# Access Compliance Report

## Public Rights-of-Way

### (Curb Ramps)

Intersection ID: 8350	Main Street: LASALLE_ST	Cross Street: CUSTER_ST	Location: SW
ADA ID: 1A90DC922390	Ramp Type: Perp	Initial Pass/Fail: Fail	Overall Compliance: No
		Severity Score: 22.5

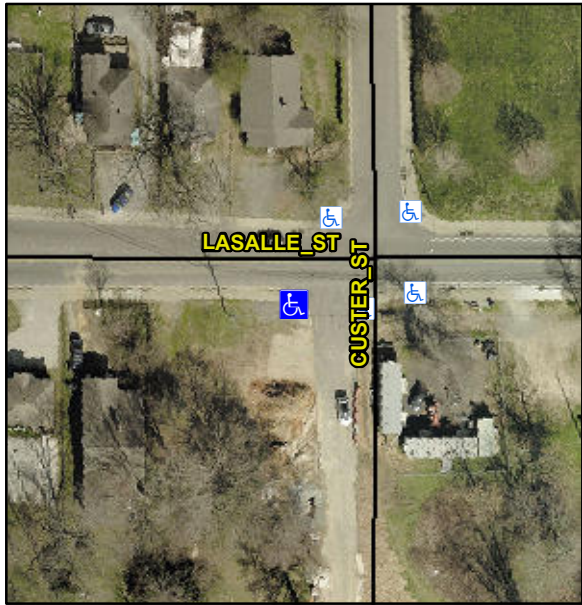
Codes/Mitigation Info/Possible Solution			Field Measurements/Component Compliance					
	Possible Solutions:		Compliance	Description	Data	Compliance	Description	Data
	Remove & Replace Entire Ramp.		N/A	Ramp Length (in)	59.5	No	Ramp Slope (%)	10.0
			No	Ramp Width (in)	36.0	No	Ramp XSlope (%)	5.0
			N/A	Flare Type LT	N/A	N/A	Flare Type RT	N/A
			N/A	Flare Slope LT (%)	N/A	N/A	Flare Slope RT (%)	N/A
			N/A	Flare Traversable LT?	N/A	N/A	Flare Traversable RT?	N/A
			N/A	Landing Length (in)	N/A	N/A	DWS Provided?	N/A
			N/A	Landing Width (in)	N/A	N/A	DWS Contrast?	N/A
			N/A	Landing Slope (%)	N/A	N/A	DWS Length (in)	N/A
			N/A	Landing X Slope (%)	N/A	N/A	DWS Full Width?	N/A
<p>Surveyor Notes:</p> <p>N/A</p> <p>PROW/ADA:</p> <p>Not Found, R304.5.1, R304.2.2, R304.5.3</p>			N/A	Landing Curb? (Y/N)	N/A	N/A	DWS Offset (in)	N/A
			N/A	Shared Landing?	N/A			
			N/A	Gutter Ponding?	N/A	N/A	Gutter Slope (%)	N/A
			N/A	Gutter Lip Ht (in)	0.5	N/A	Gutter X Slope (%)	N/A

N/A	Painted X Walk1?	No	N/A	Painted X Walk2?	N/A
				X Walk 1 Direction	To E		X Walk 2 Direction	N/A
			N/A	X Walk 1 Width (in)	N/A	N/A	X Walk 2 Width (in)	N/A
				X Walk 1 Slope (%)	1.0		X Walk 2 Slope (%)	N/A
				X Walk 1 X Slope (%)	3.6		X Walk 2 X Slope (%)	N/A
			N/A	Ramp inside XWalk1?	N/A	N/A	Ramp inside XWalk2?	N/A
			Road Slope (%)	N/A	N/A	Clear Space?	N/A	
			Road X Slope (%)	N/A	N/A	Clear Space to XWalk (in)	N/A	
		N/A	Any Obstructions?	N/A	N/A	Storm Grate/Utility Hazard?	N/A	
			Obstruction Type			Storm Grate/Utility Type		
					N/A			N/A
						Yes	Surface Condition? (G/P)	Good
